Item Name: Baggage Compartment Protector - Floor

DART SERVICE INSTRUCTION

TO AMEND INSTALLATION INSTRUCTIONS IIN-D407-781-2 REV. A OR LATER APPROVED REVISION
AND INSTRUCTIONS FOR CONTINUED AIRWORTHINESS ICA-D407-781 REV. 3 OR LATER REVISION

A	NEW ISSUE		13.04.08
REV.	DESCRIPTION	BY	DATE
DESIGN			
DRAWN			
CHECKED			
MFG. APPR.	N/A		
APPROVED			
DE APPR.			
DATE	13.04.08		
DART AEROSPACE LTD HAWKESBURY, ONTARIO, CANADA			
DRAWING NO. DSI 9649		REV. A SHEET 1 OF 2	
TITLE ALTERNATE INSTALL		SCALE NTS	
COPYRIGHT © 2013 BY DART AEROSPACE LTD. THIS DOCUMENT IS PRIVATE AND CONFIDENTIAL AND IS SUPPLIED ON THE EXPRESS CONDITION THAT IT IS NOT TO BE USED FOR ANY PURPOSE OR COPIED OR COMMUNICATED TO ANY OTHER PERSON WITHOUT WRITTEN PERMISSION FROM DART AEROSPACE LTD.

**FIGURE 1 - D3879-1 BAGGAGE COMPARTMENT WALL
PROTECTOR - ALTERNATE INSTALLATION**

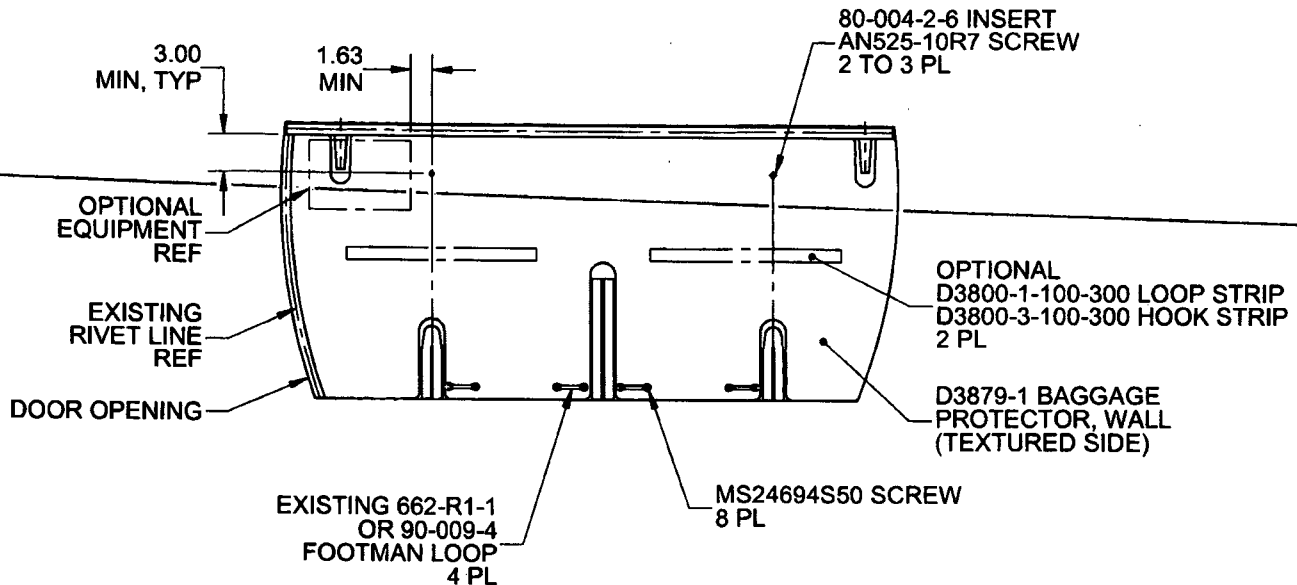
In some aircraft, the top portion of the D206-781-041 Baggage Compartment Wall Protector Kit cannot be installed as indicated in IIN-D407-781-2. The purpose of this DSI is to provide an alternate mounting method to fasten the top portion of the D206-781-041 Baggage Compartment Wall Protector Kit.

It is acceptable to replace qty(2) D3930-1 Clips with qty(2) 80-004-2-6 Inserts. Locate and mark location of the two attachment holes on the baggage compartment wall as shown in Figure 1 of this service instruction. Install 80-004-2-6 Inserts at the marked locations in accordance with Section 3-2-12 of BHT-206-SRM-1. It is acceptable to trim the wall protectors to accommodate optional equipment or transfer attachment holes to the wall protector and install the optional equipment on top of the wall protector with longer fasteners.

Amend the D206-781-041 Baggage Compartment Wall Protector Kit parts list as follows:

Qty -061	Qty -031	Qty -041	Part Number	Description
X			D206-781-061	BAGGAGE COMPARTMENT PROTECTOR KIT (FLOOR AND WALL)
1	X		D206-781-031	BAGGAGE COMPARTMENT FLOOR PROTECTOR KIT
1		X	D206-781-041	BAGGAGE COMPARTMENT WALL PROTECTOR KIT
		2	AN525-10R7	SCREW
		2	80-004-2-6	INSERT
